APPENDIX 6: HISTORIC PRESERVATION REVIEW BOARD STAFF REPORTS

**HISTORIC PRESERVATION REVIEW BOARD
STAFF REPORT AND RECOMMENDATION**

Landmark/District: **Decatur Street Car Barn/Northern Bus Garage** Agenda
Address: **4701 14th Street, NW** Consent Calendar
Meeting Date: **May 28, 2020** New Construction
H.P.A. Numbers: **20-176** Alteration
 Demolition

Figure 18. Proposed upper level plan of bus garage with historic overlay; the 14th street (west) façade will be retained along with the administrative offices and tower (Wendel)

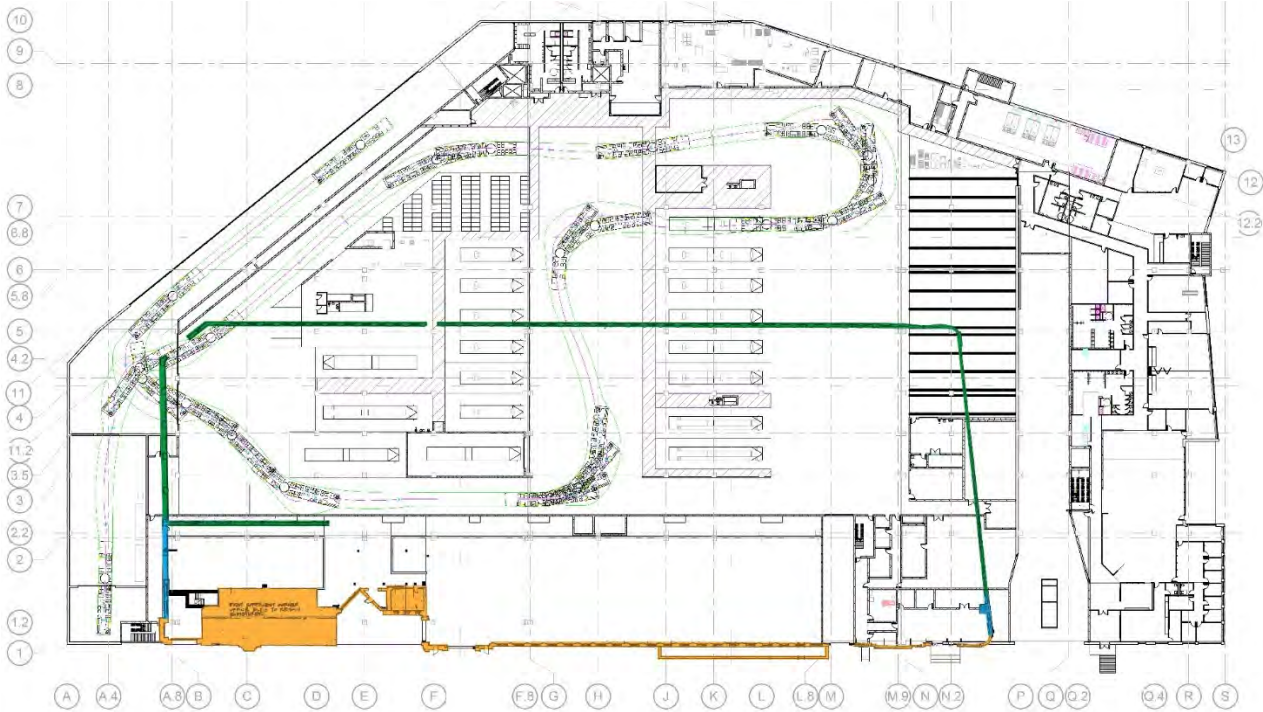
The drawing below shows the existing historic masonry walls overlaid on the design for the upper level of the new bus garage. (See **Figure 18**) Due to the alterations of the historic fabric and the need for a new bus garage that can accommodate efficient and safe vehicle circulation for 40'-0" and 60'-0" articulated buses, the existing bus garage must be replaced. The new bus garage will also ensure adequate height clearance for newer diesel buses and future overhead charging for electric buses, be reorganized to expand the number of maintenance bays and bus storage parking, incorporate a retail element for increased community integration, will be able to 100 percent filter exhaust air, and will reduce operating costs through sustainable strategies. The replacement bus garage project proposes that the east wall and the majority of the north and south walls be demolished. However, the entire west façade, including the administrative offices and tower, would be retained and preserved allowing for the conservation, repair, and cleaning of areas of damage, weathering, soiling, and staining. There is also the opportunity to replace the existing widows with replicas of the historic windows and restore window openings that were previously infilled or replaced with louvers. Such treatments would be developed as design coordination for the project continues. Portions of the upper level of the north and
